# Access Compliance Report

## Public Rights-of-Way

### (Curb Ramps)

Intersection ID: N/A	Main Street: ARDREY_KELL_RD	Cross Street: WAVERLY_WALK_AV	Location: SW
ADA ID: 0CD6F08798C6	Ramp Type: Directional1	Initial Pass/Fail: Fail	Overall Compliance: No
		Severity Score: 12.5

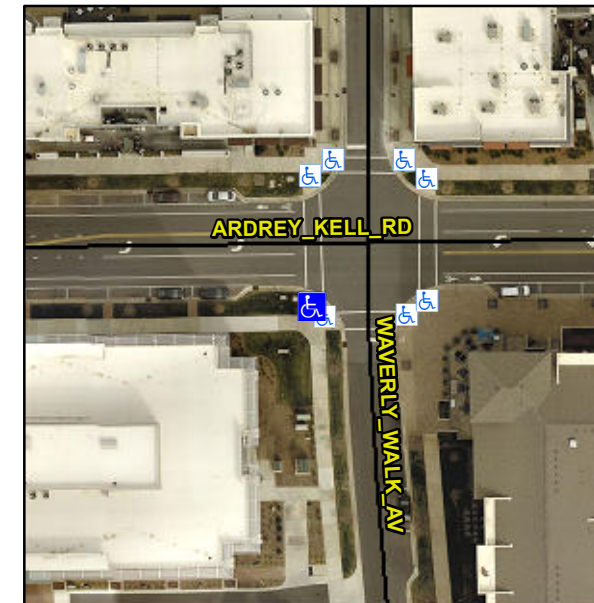
**R304.2.2**

Compliance	Description	Data	Compliance	Description	Data
N/A	Ramp Length (in)	68.0	N/A	Grade Break?	N/A
Yes	Ramp Width (in)	86.0	N/A	Grade Break Slope (%)	0.0
No	Ramp Slope (%)	9.6	N/A	Grade Break XSlope (%)	0.0
Yes	Ramp XSlope (%)	1.1			
N/A	Flare Type LT	N/A	N/A	Flare Type RT	N/A
N/A	Flare Slope LT (%)	N/A	N/A	Flare Slope RT (%)	0.0
N/A	Flare Traversable LT?	N/A	N/A	Flare Traversable RT?	N/A
N/A	Landing Length (in)	0.0	N/A	DWS Provided?	N/A
N/A	Landing Width (in)	0.0	N/A	DWS Contrast?	N/A
N/A	Landing Slope (%)	0.0	N/A	DWS Length (in)	N/A
N/A	Landing X Slope (%)	0.0	N/A	DWS Full Width?	N/A
N/A	Landing Curb? (Y/N)	N/A	N/A	DWS Offset LT (in)	N/A
N/A	Shared Landing?	N/A	N/A	DWS Offset RT (in)	N/A
N/A	Gutter Ponding?	0.0	N/A	Gutter Slope (%)	N/A
N/A	Gutter Lip Ht (in)	0.0	N/A	Gutter X Slope (%)	N/A
N/A	Painted X Walk1?	Yes		Road Slope (%)	4.6
	X Walk 1 Direction	To N		Road X Slope (%)	0.4
	X Walk 1 Width (in)	111.0		Clear Space?	N/A

**Remove & Replace Entire Ramp.**
